Part 21 (PAR)

PART 21 REPORT - NOTIFICATION OF DEVIATION REGARDING HK CIRCUIT BREAKER PIVOT PIN

Subject: 10CFR Part 21 Notification of Deviation re. HK Circuit Breaker Pivot Pin

Figure 1 – Pivot Pin

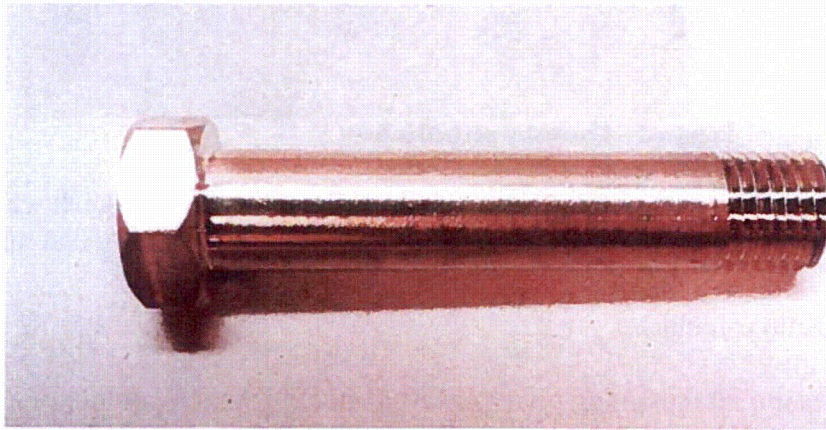
1. This letter provides notification of a failure to comply with specifications associated with a pivot pin, part number 193610B00 (see Figure 1), used in HK circuit breakers. This pin is used as the pivot point for the arcing contacts. Information is provided as specified in 10CFR21 paragraph 21.21(d) (4).

Figure 2 – Correctly peened pin

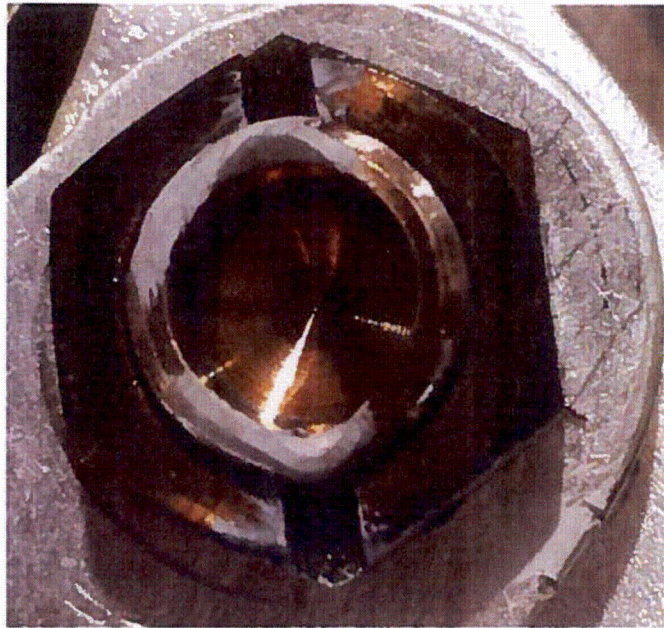
During a breaker refurbishment at the ABB Florence facility, it was noted that a pivot pin cracked at the threads during installation. The peening operation performed on the threaded end of the pivot pin (see Figure 2) caused cracking due to brittle failure. Laboratory testing revealed that this particular pivot pin was made from an incorrect material.

- a. Removed all remaining pivot pins from stock. (Action complete)
- b. Contact primary vendor to investigate cause and correct on future orders. (Action Complete)
- c. Added material verification to our Critical Characteristic cards for future orders. (Action Complete)
- d. Upgrade of ABB's spectrometer to analyze this silicon bronze material on all future shipments. (Action Complete)
- e. Obtained and tested, via qualified laboratory, a batch of pivot pins to supply to customers. (Action Complete)
- f. Notification of the potential existence of this deviation to affected customers (Action to be completed the week of 10 August 2015)

If the part was installed in a breaker or assembly and the threaded end did not show signs of failure or fracture at installation, it is not considered to be part of the suspect population. ABB recommends that these pivot pins be visually inspected at the next convenient maintenance cycle.

If the pivot pin is in their inventory as a component item or in a kit and was shipped in the time interval of the suspect material, it should be returned to ABB for replacement.
